## Metro Outer Joint Development Assessment Panel Agenda

**Meeting Date and Time:** Thursday, 14 May 2020; 1:30pm  
**Meeting Number:** MOJDAP/3  
**Meeting Venue:** This meeting is available for members of the public to attend via electronic means

|    | 10.1 Lot 104 & 105 (8 & 10) Brechin Court, Duncraig .....                                   | 3 |

The development modifications have not reduced the yield or significantly changed the proposal since the JDAP's original decision. The key changes that have been made are:

APARTMENTS - 5,6,12,13  
1 : 50

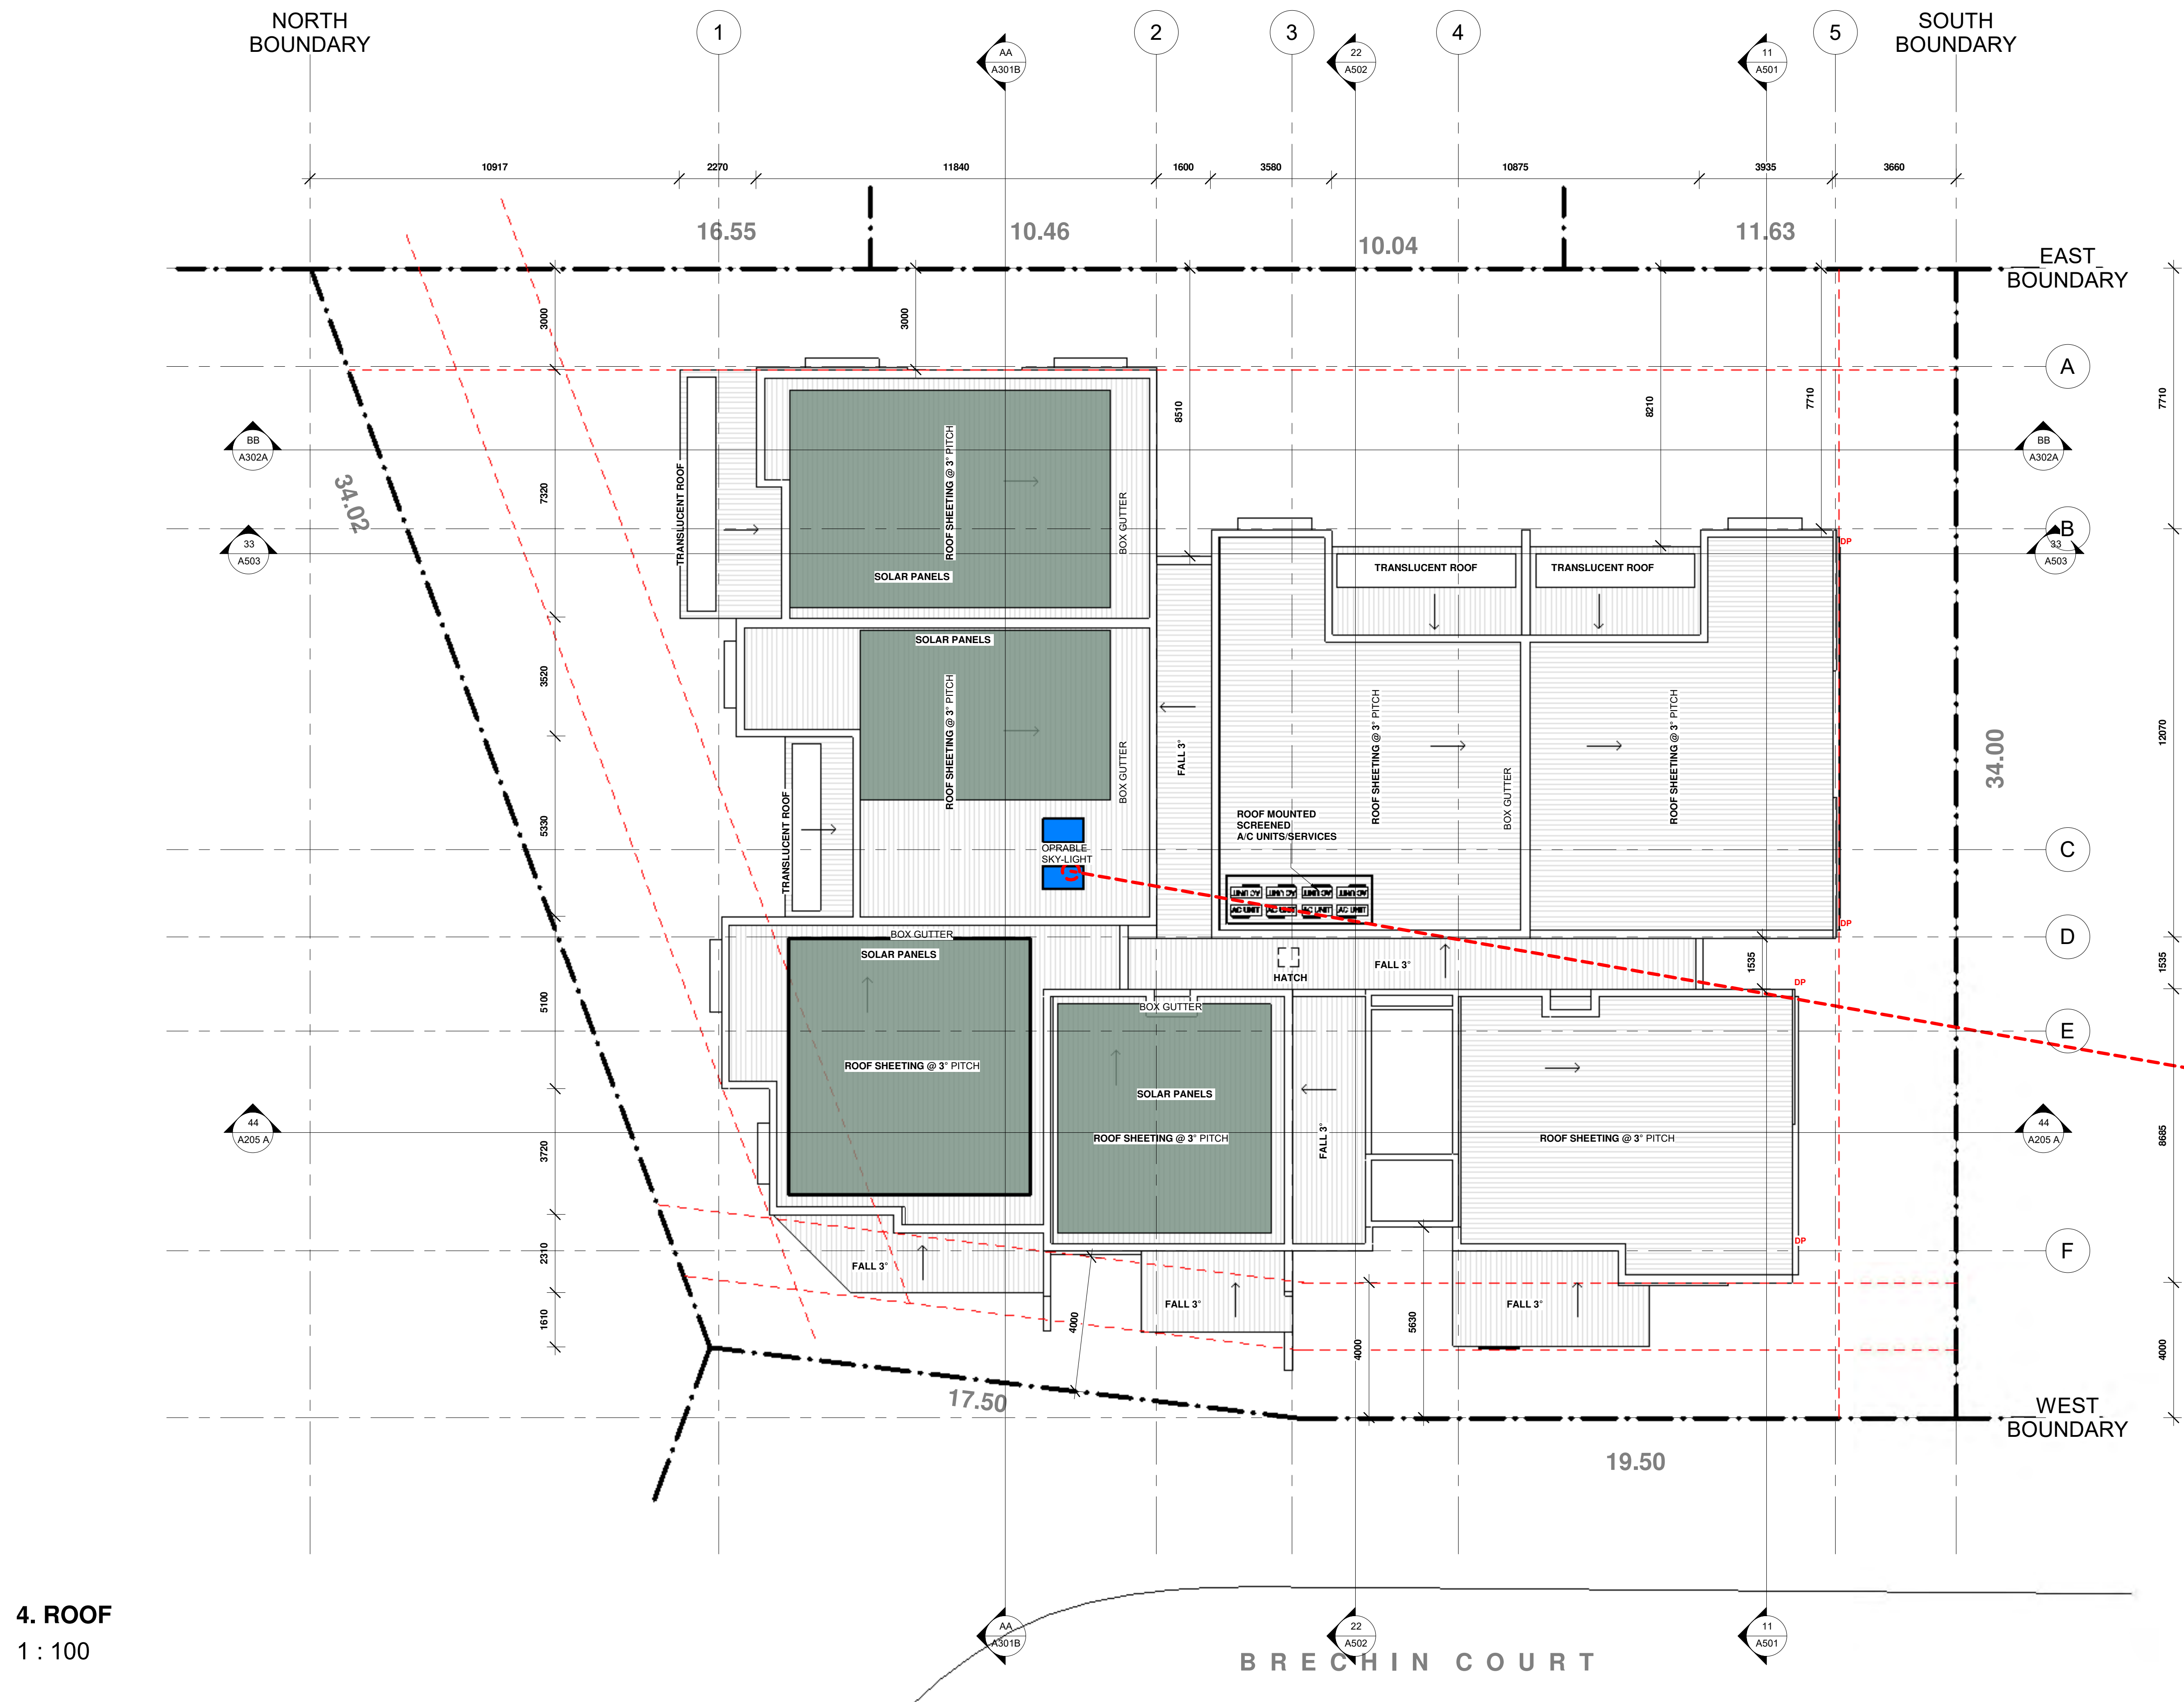
| JDRP comments  | Summary of applicant's response  |
|--|--|
| Screening notations for the balconies on the floor plans relating to apartment 4 and 11 do not match screening provided on elevations.   | Revised plans include the screening on both floor plans and elevations.  |

SOUTH ELEVATION  
1 : 100

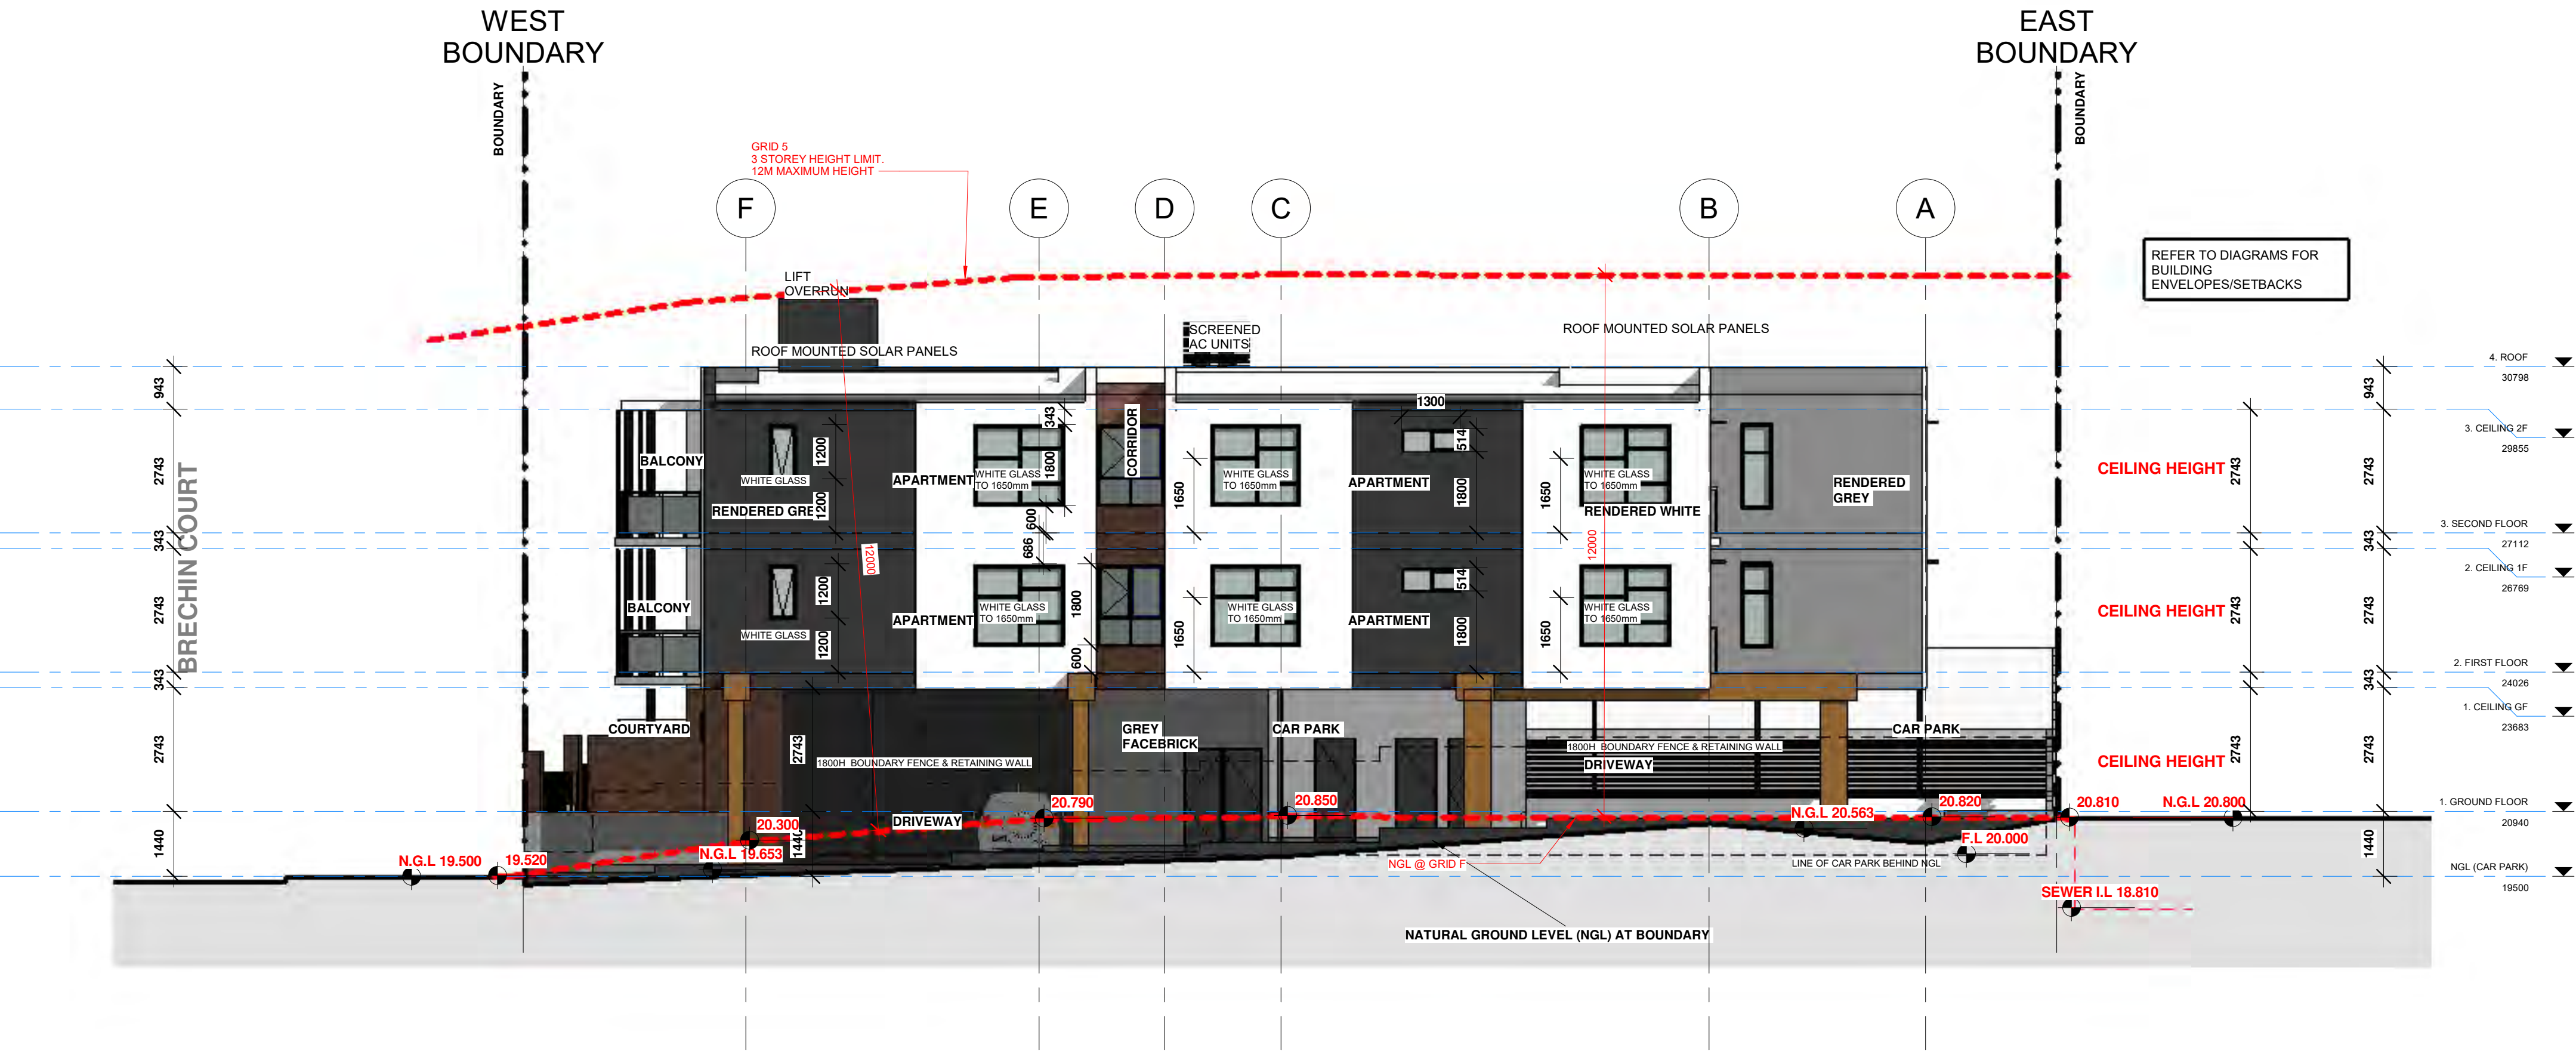
| JDRP comments  | Summary of applicant's response  |
|--|--|
| Further detail is required on the translucent panelling over balconies.  | Other projects have incorporated similar panelling which has worked.   |

Setbacks have also been increased to the southern elevation of the development to reduce the extent of overshadowing on the adjoining property. However the increased setbacks are not substantial in the context of the overall development and how the development transitions between neighbouring sites developed at a lower density. It is therefore considered that the modified proposal does not meet the element objectives in this regard.

COMMON AREA - ARBORS OVER SEATED AREA

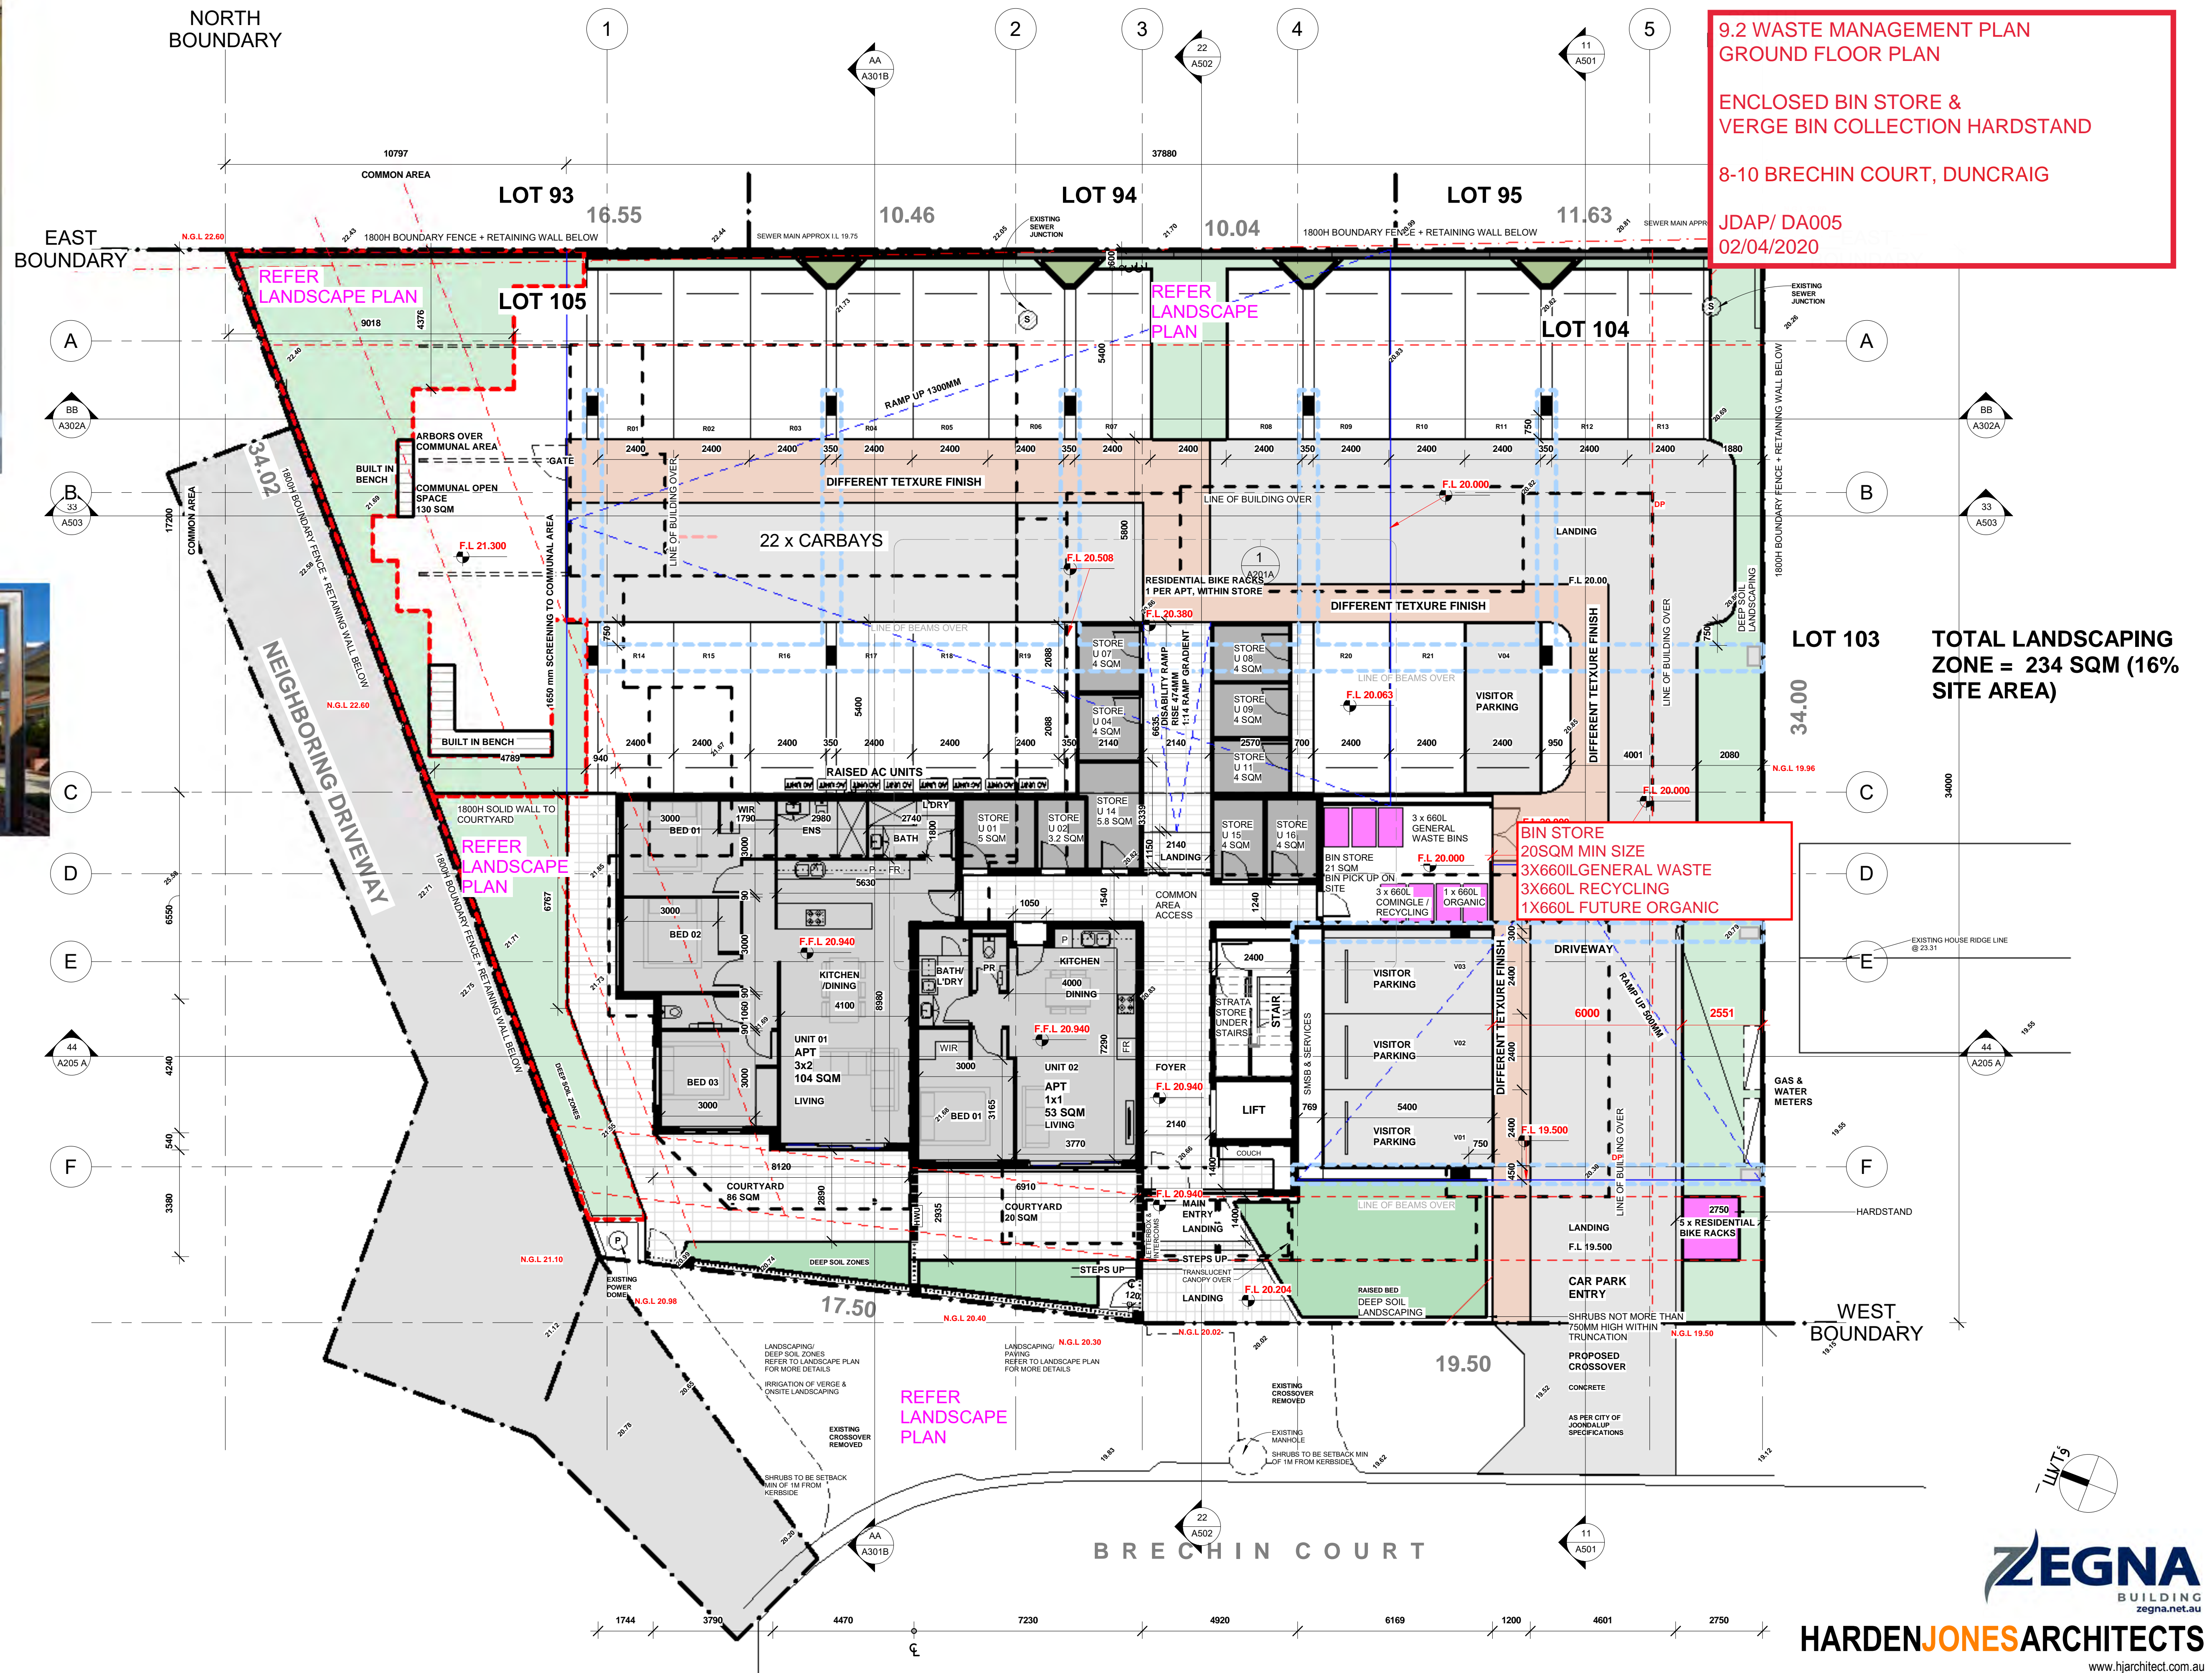
| <b>JDRP comments</b>   | <b>Summary of applicant's response</b>   |
|--|--|
| May need to consider a pergola style roof to the communal open space to provide shade to this area.  | Arbours have been included over the communal open space, however the species of creeper associated with the arbours has not been specified.  |

The deep soil areas are located on the southern and northern boundaries, as well as in front of the visitor parking area within the street setback area. Landscaping is proposed to be integrated with the communal open space, including provision of the large tree in the north eastern corner of the site. However, details of plant species growing over the arbours within the communal open space have not been specified.
